26 March 2018

Project Ref: NRC18.10  
MWWUG\_GMCP\_Comments.doc

## **Motutangi Waiharara Water User Group (MWWUG) Groundwater Monitoring and Contingency Plan**

Figure 2. Monitoring Bore Location Map.

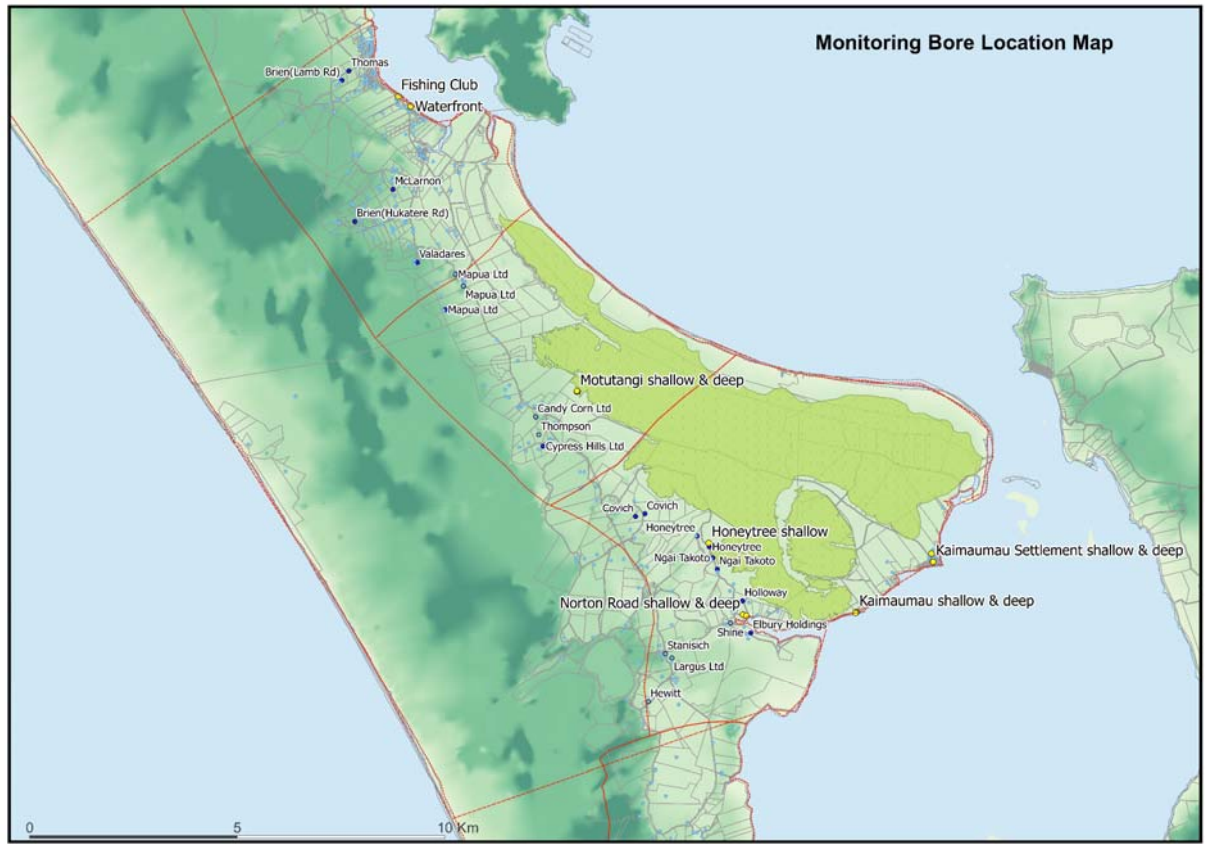
It is also noted that several grid references provided in Table 3 are either incorrect (e.g. in the case of the Honeytree Farms shallow piezometer) or inconsistent with locations shown on Figure 2 (e.g. Shine, Holloway and Elbury Holdings production bores). Grid references for individual production bores should be confirmed by the applicant. The map should be updated to ensure consistency with grid references listed and provide a key to clearly differentiate different monitoring site types.

Commented [BH4]: Grid references require confirmation

Commented [BH4]: Grid references require confirmation
